County Plan No.: SP-145-89
Project Name: GOVERNORS LAND - TRAVIS POND
Stormwater Management Facility: WET POND

Re: Governor's Land - Travis Pond
County Plan No. SP-145- 89
Stormwater Management Facility
County BMP ID Code: JR 016

The Environmental Divisions has reviewed a record drawing (asbuilt) and postconstruction geotechnical report (ECS # 6221 dated December 31st 2000) as submitted to our office for the above referenced BMP. The record drawing provides asbuilt information for a large lake BMP situated between the Whitaker Island Block A and the Travis Pond sections of Governor's Land near golf course Fairway # 9.

AS-BUILT - TRAVIS POND EASTERN GRADING PLAN

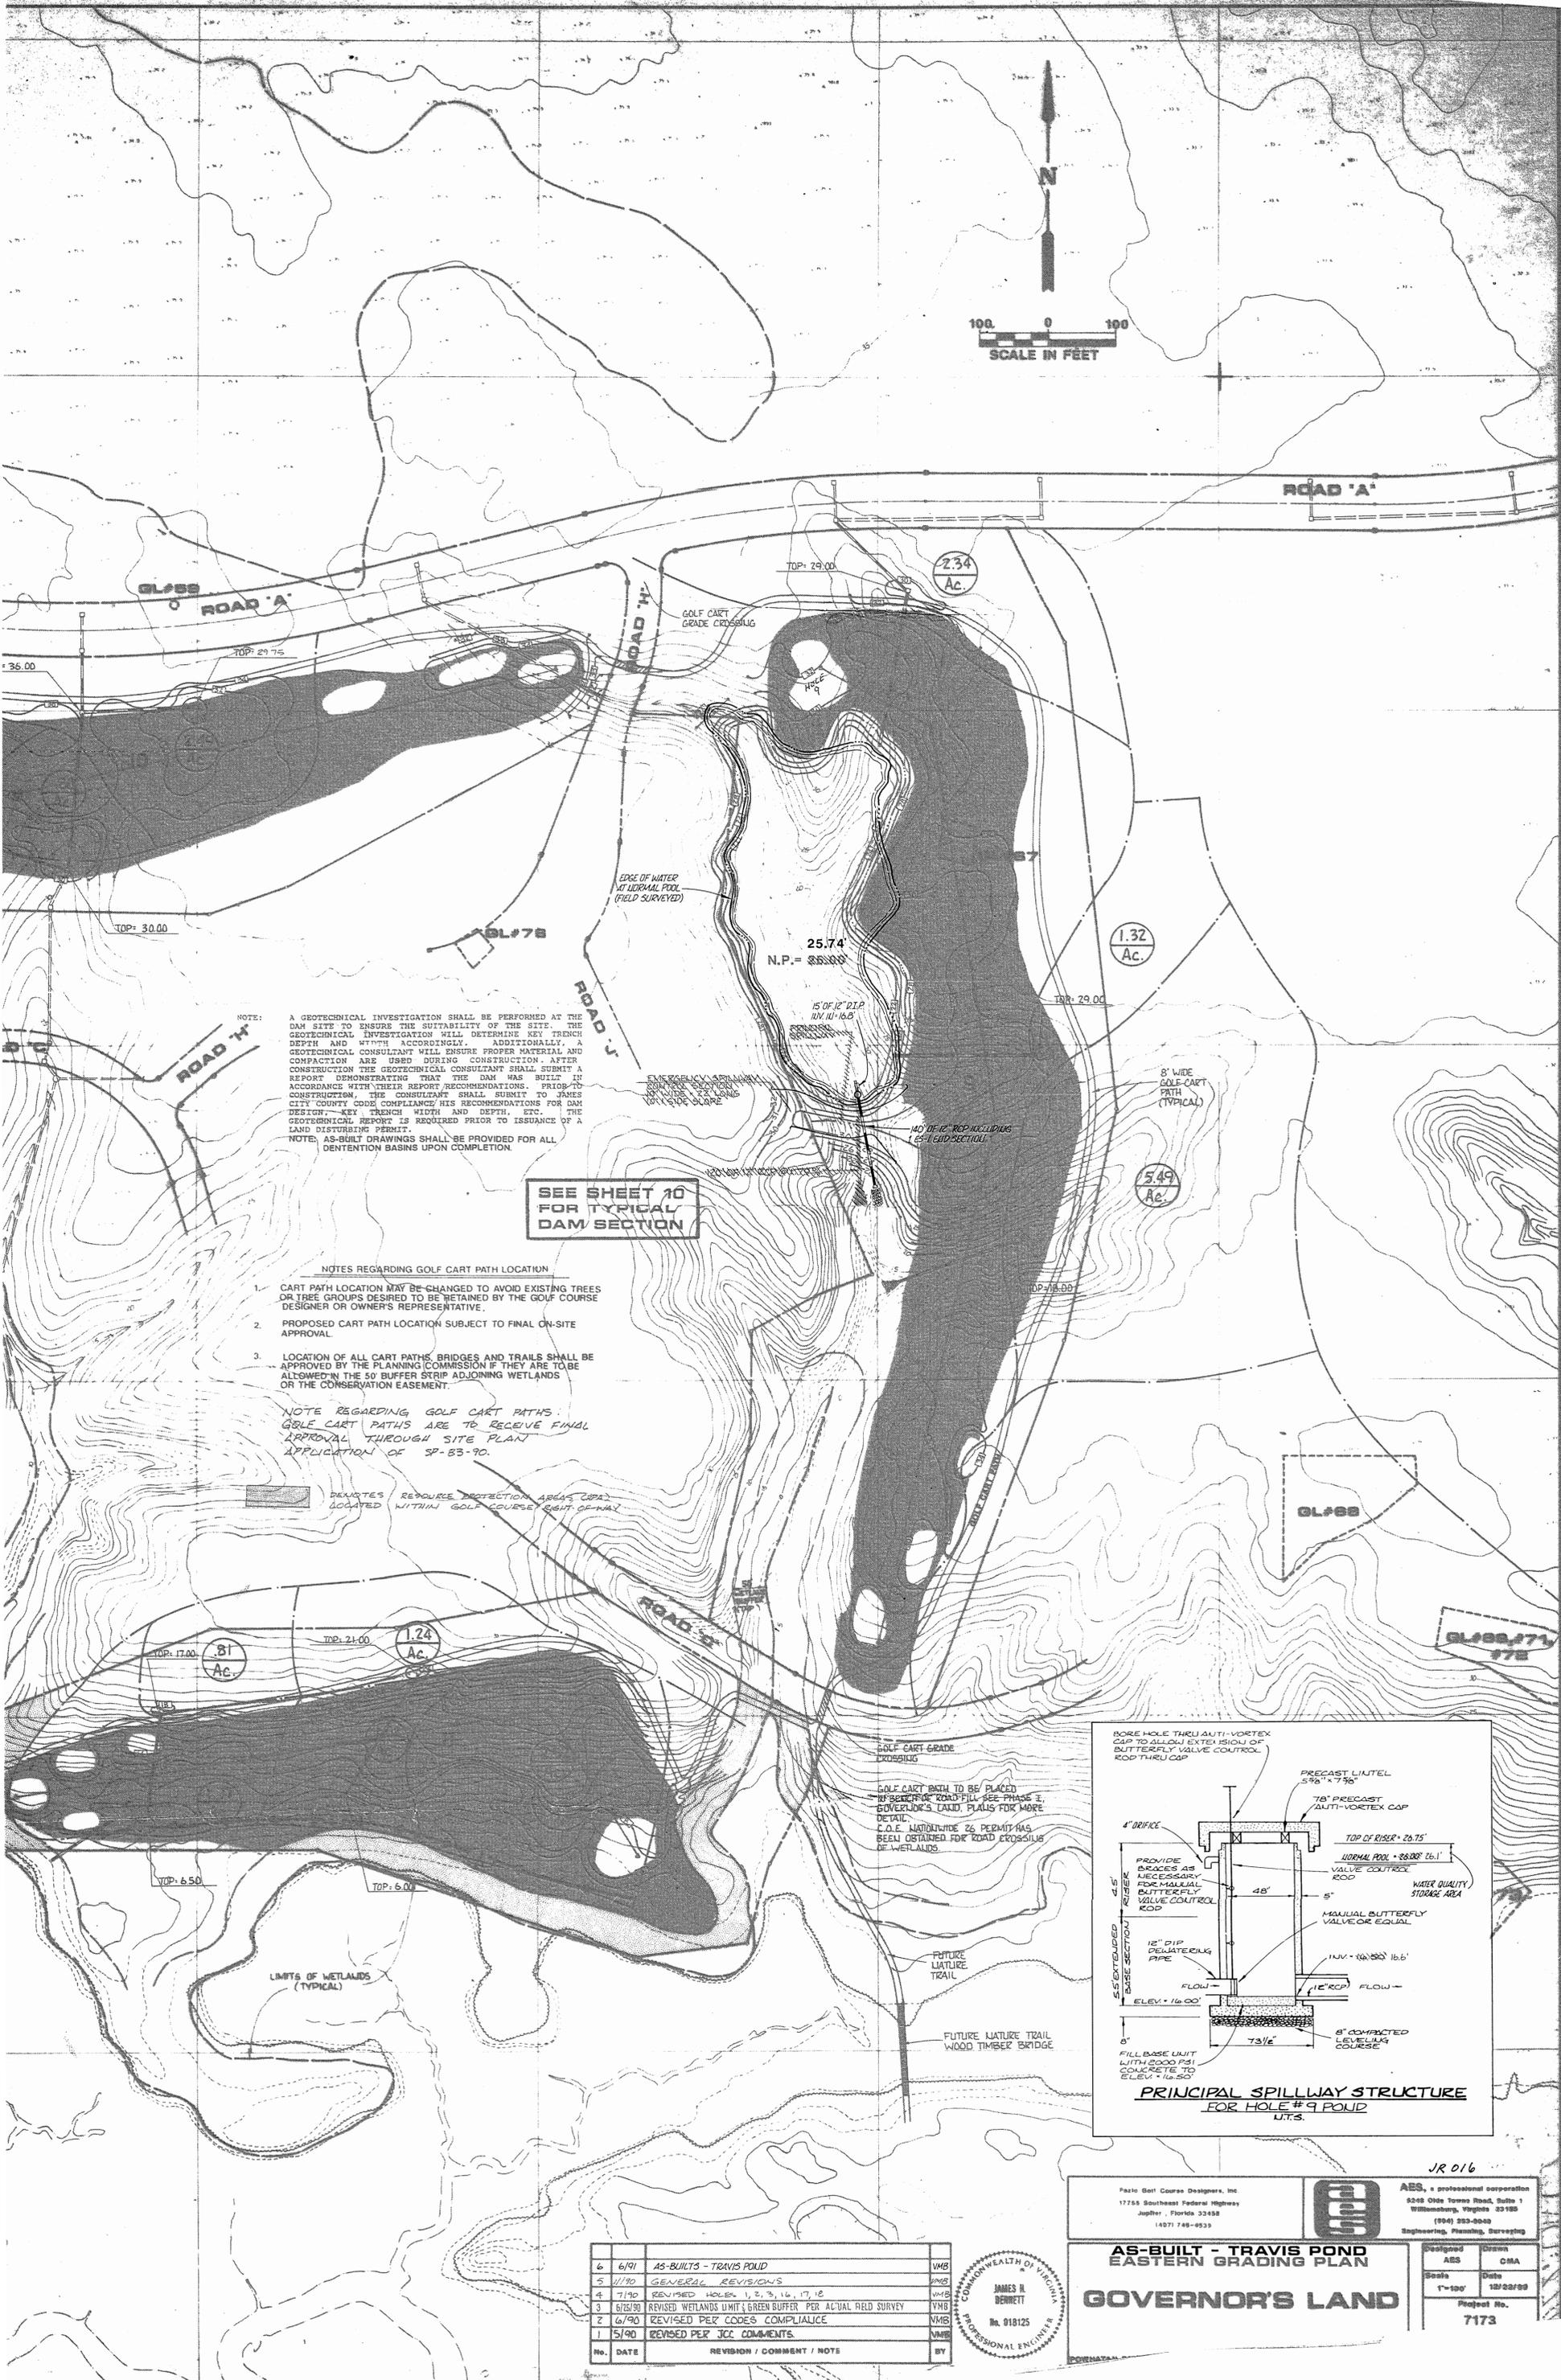
2. Provide an asbuilt elevation for the bottom of the pond at the upstream toe of the dam embankment near the invert elevation of the pond drain to verify that design depth (elevation) was achieved and that excessive sedimentation does not exist in the bottom of the facility. The approved plan shows a design elevation at El. 16.80 or approximately 9.5 ft. below current normal pool.

Spot elevations for the bottom of the pond were added to plan view of the drawings. From this information, there is no significant sediment accumulation in this pond.

**DAM CROSS SECTION B-B
 9TH HOLE POND**

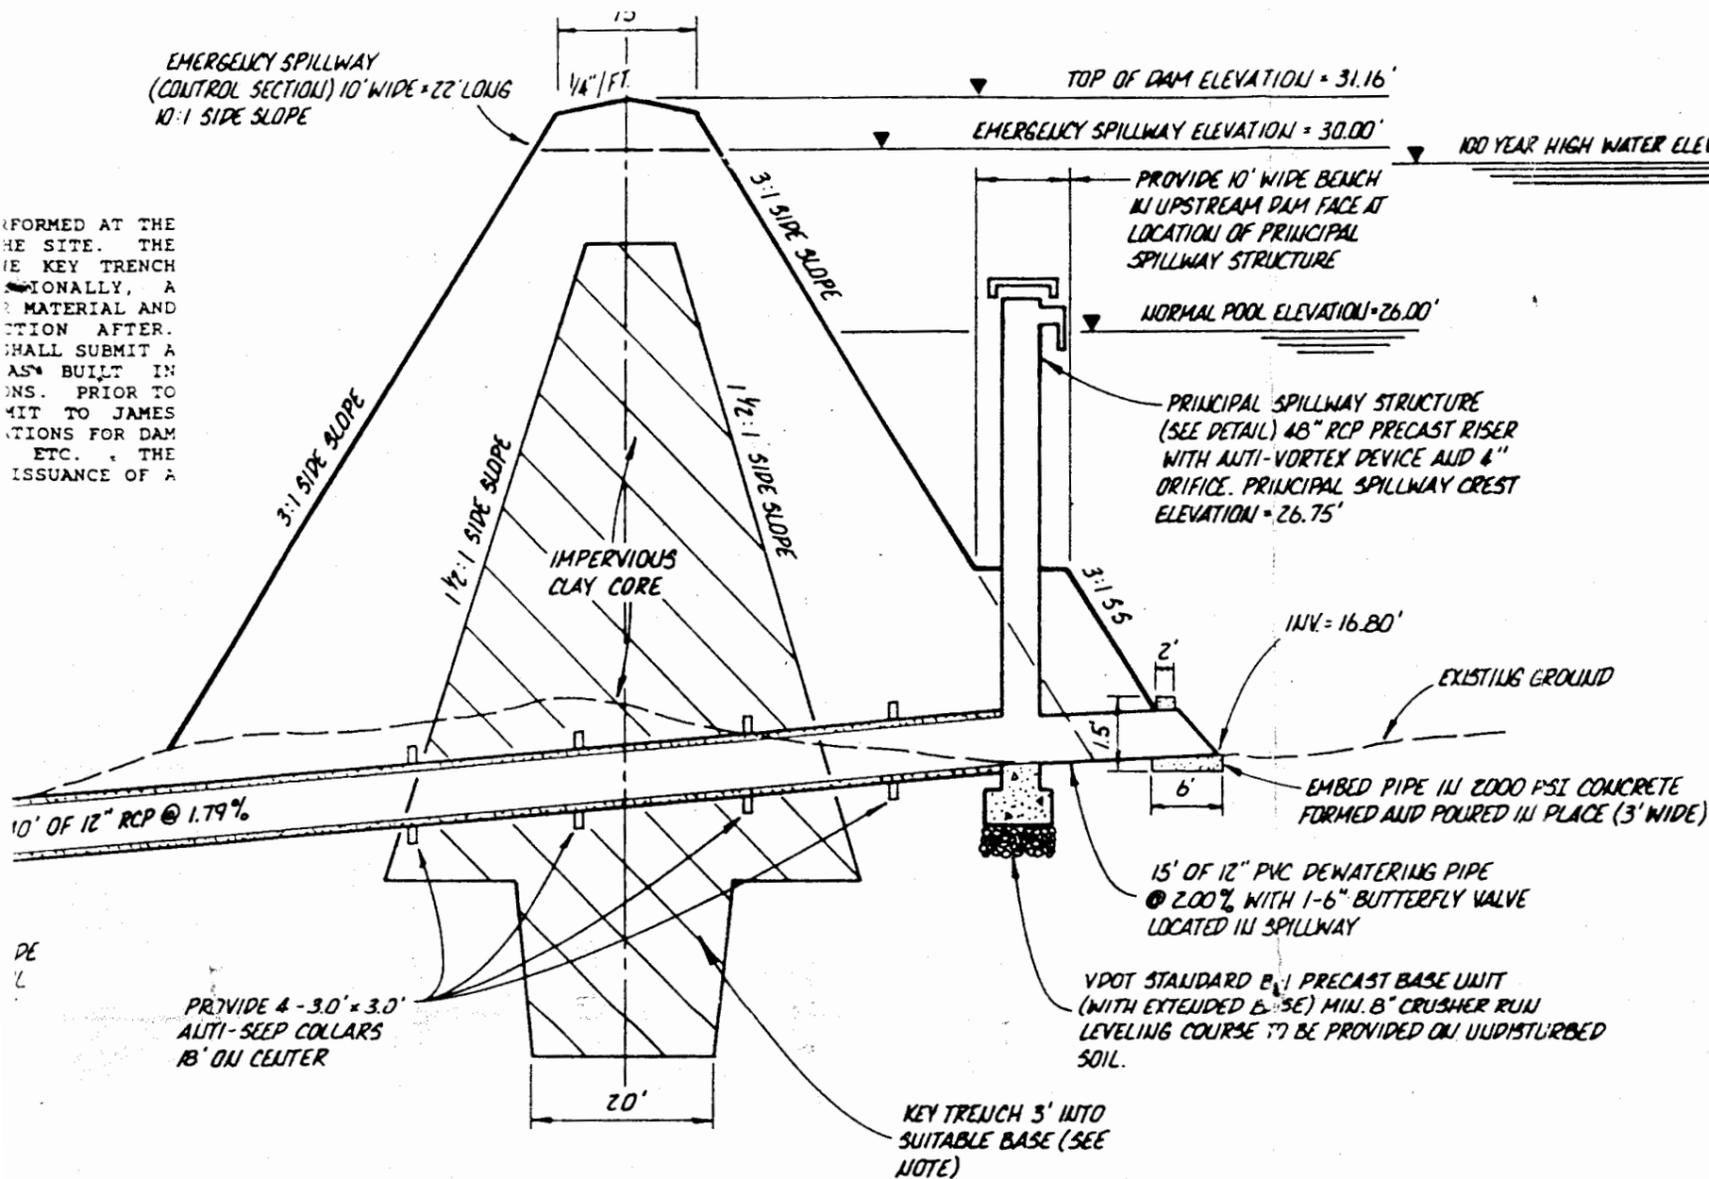
3. Based on field observations, it does not appear that an emergency spillway was present on the facility. The approved plan called for an emergency spillway 10 ft. wide with 10H:1V side slopes at El. 30.0. However, Section B-B and the 1"=20 ft. inset plan on the record drawing indicate an asbuilt emergency spillway elevation at El. 29.92. Show the approximate location of the emergency spillway as constructed on 1"=20' inset plan portion of the record drawing.

4. Based on the approved plan, proposed top of dam was at El. 31.16 and design high water is at El. 29.70, thus the approved design was intended to achieve 1.46 ft. of freeboard. Based on asbuilt data on the Section B-B drawing, asbuilt elevations for top of dam ranged from El. 30.2 to El. 30.7 and emergency spillway crest was at El. 29.92. Firstly, this does not agree with asbuilt spot elevation data shown on the 1"=20' inset plan which shows dam crest elevations even lower than El. 30.2 in some locations, especially on the west abutment of the dam. Secondly, asbuilt data shows that proposed top of dam elevations (El. 30.16) were not achieved nor were consistent top of dam elevations achieved to meet minimum freeboard requirements. Minimum freeboard requirements are 1 ft. between design high water and top of dam, if an emergency spillway is present on the facility. This would correspond to consistent minimum top of dam elevations at El. 30.7 if an emergency spillway was or will be constructed. Therefore, it appears most of the top of dam crest was not constructed high enough to even meet minimum freeboard standards. Provide additional asbuilt spot elevation data along top of dam to show proposed top of dam elevations or top of dam elevations to minimum El. 30.7 were achieved; or alternatively, construct the dam to minimum top of dam El. 30.7 or provide an asbuilt hydraulic routing to ensure minimum freeboard of 1 ft. exists at the BMP.

The approximate location of the emergency spillway has been added to the plan sheet in the 1"=20' inset and the elevation has been corrected on the detail sheet.
